UPDATED - May 22, 2020

Project Name: The Davis Companies, 75/109 Smith Place

Subject: Planning Board Hearing #2 Presentation and Response to Comments

Jacobs The Davis Companies FULTON SMITH PLACE PROJECT, CAMBRIDGE MA REDUCTION OF SURFACE PARKING FUTURE/PROPOSED BUILDING

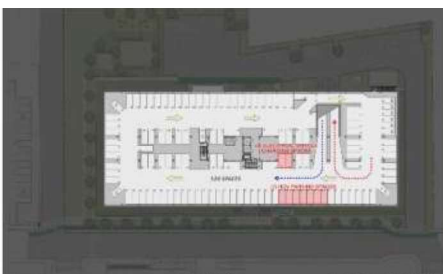
A7. *Reducing the amount of surface parking, both to improve the appearance of the site and to increase the amount of permeable surface.*

Response: The Proponent has moved 9 spaces from the surface lot into the garage. After reconfiguring the surface parking, approximately 5,400 sf of parking lot has been converted to permeable open space.

- Proposed updated site plan, after 5,400 sf parking area reduction.
- Proposed design creates an outdoor employee area, with additional trees and a permeable "patio" area.
- A total of 9 spaces were removed from the surface parking area and move to the underground parking garage.

Slide 45 **Proposed Ground Floor Plan**

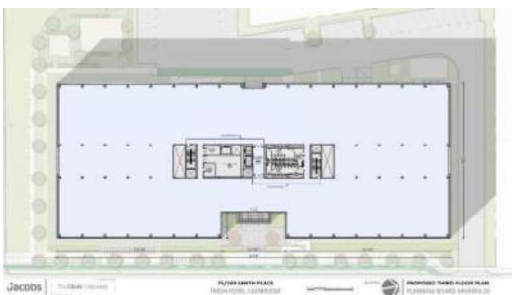
C5. *Creating a courtyard on Smith Place to accentuate the division of the façade into two parts. (The Smith Place façade is approximately 360 feet long, well over the 200-foot maximum length recommended by the Alewife District Plan.)*

Response: The attached plans, elevations and 3d views show a courtyard has been added to the design to break up the massing into two parts

- Elements added/adjusted in response to comments
 - Added courtyard to break up building massing along Smith Place
 - Reduced length of entry stairs per CDD staff suggestions
 - Added additional landscaping into entry plinth

Slide 48 **Proposed Penthouse Plan**

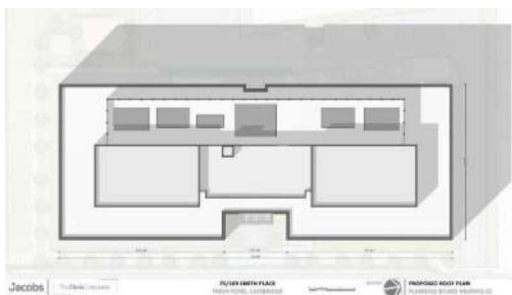
C6. *Committing not to locate tenant rooftop equipment outside of the penthouse screening.*

Response: The Proponent commits that all visible mechanical equipment will be located behind a mechanical screen.

- Elements added/adjusted in response to comments
 - Removed mechanical equipment on Smith Place side of the penthouse
 - Adjusted the massing of the penthouse to create more interest, changes made in both plan and elevation
